**Consideration of draft amendments to
existing UN Regulations submitted by GRSP**

Proposal for Supplement 2 to the 03 series of amendments to UN Regulation No. 129 (Enhanced Child Restraint Systems)

Submitted by the Working Party on Passive Safety*

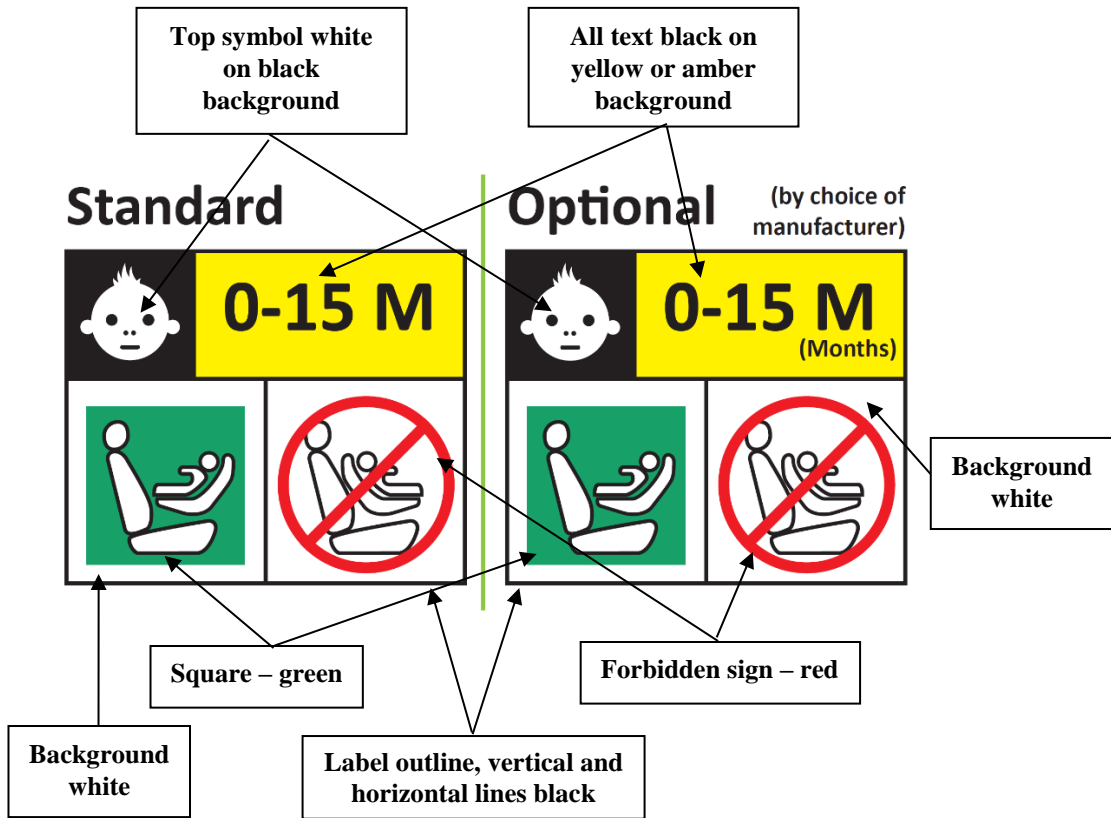
Paragraph 4.5., amend to read:

"4.5. Integral Enhanced Child Restraint Systems that can be used forward and rearward facing, shall have the following label permanently attached on the part hosting the child and visible to the person installing an Enhanced Child Restraint System in the vehicle:

The manufacturer shall be permitted to include the word "months" to explain the symbol "M" in the label. The word "months" should be in a language commonly spoken in the country or countries where the product is sold. More than one language is allowed.

Minimum label size 40 x 40 mm

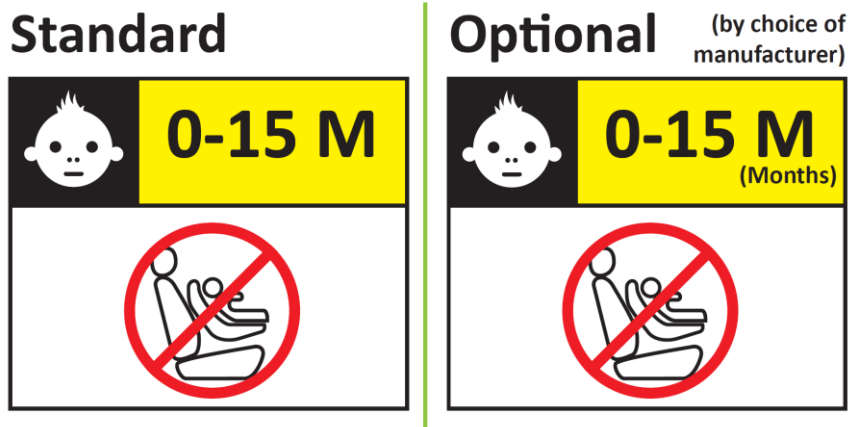
Integral Enhanced Child Restraint Systems that can be used forward facing only shall have the following label permanently attached on the part hosting the child and visible to the person installing an Enhanced Child Restraint System in the vehicle:

The manufacturer shall be permitted to include the word "months" to explain the symbol "M" in the label. The word "months" should be in a language commonly spoken in the country or countries where the product is sold. More than one language is allowed.

Minimum label size 40 x 40 mm

Figure 1
Arrangement for testing a forward-facing device

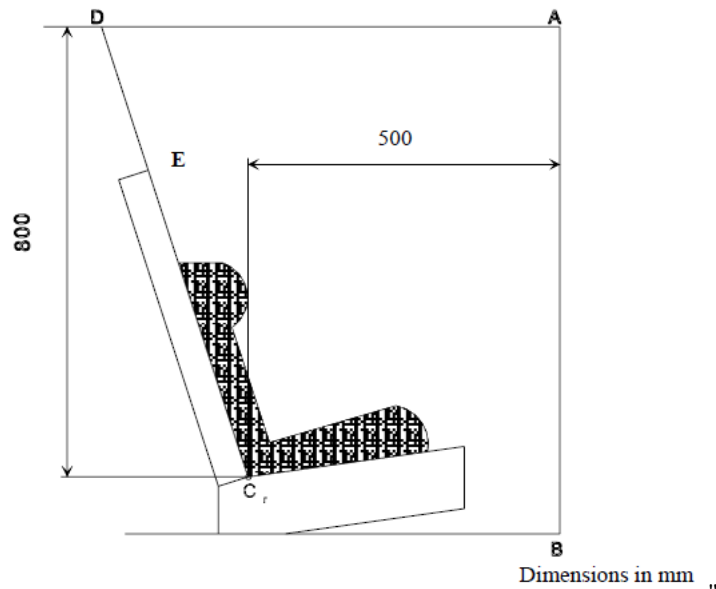
Paragraphs 6.6.4.4.1.1. and 6.6.4.4.1.1.1., amend to read:

Head excursion: No part of the head of the dummy shall pass beyond the planes BA, DA and DE as defined in Figure 1 below. However, the head of the dummy may pass beyond the DE plane, if there is part of the child restraint structure, i.e. head pad or backrest, behind the head of the dummy, at the point the head passes the DE plane.

This shall be judged up to 300 ms or the moment that the dummy has come to a definitive standstill whatever occurs first.

Except for booster seats when testing using Q10 dummy where:

- (a) The value in relation to the DA plane is 840 mm; and
- (b) The value in relation to the BA plane is 550 mm; and
- (c) The rebound phase is not considered for the assessment of the plane DA and DE.

6.6.4.4.1.1.1. Where a test is conducted in accordance with paragraph 6.6.4.1.6.2. or paragraph 6.6.4.1.8.2. above, a tolerance of +10 per cent shall be applicable to the head excursion value distance between Cr point and plane AB.

"1. Arrangements of the approval mark

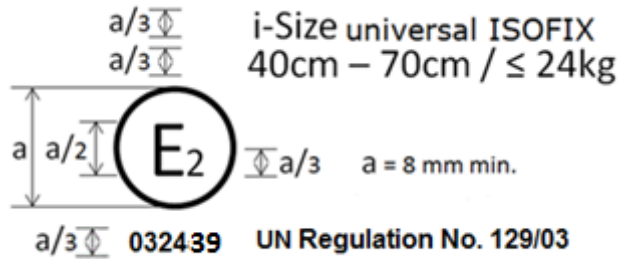
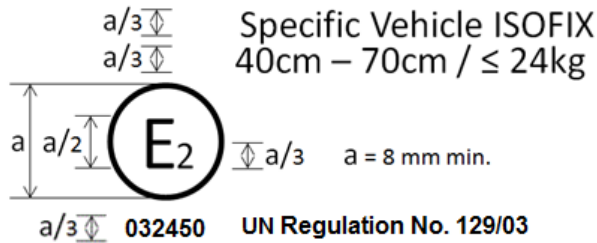
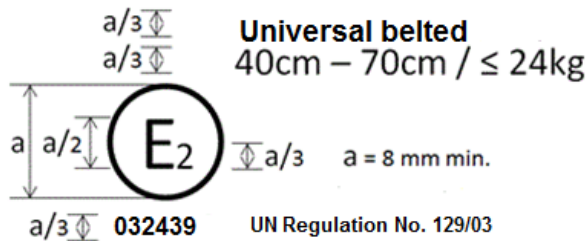
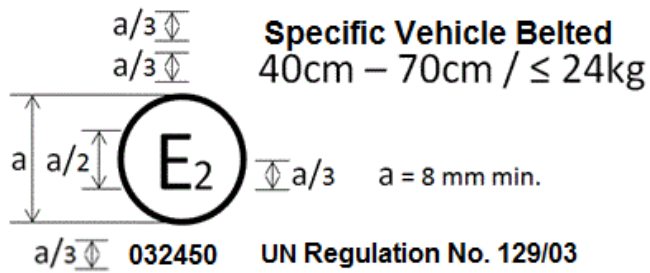
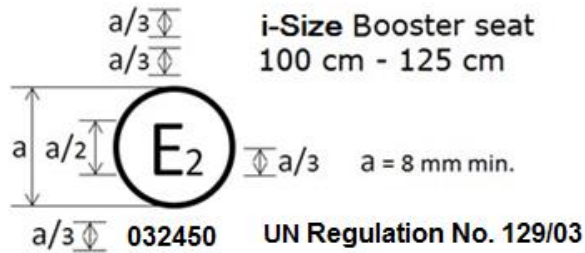
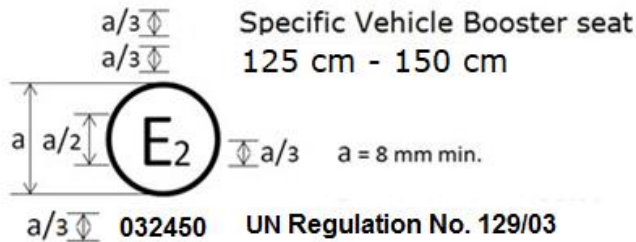
Annex 2., the example of approval markings only, amend to read:
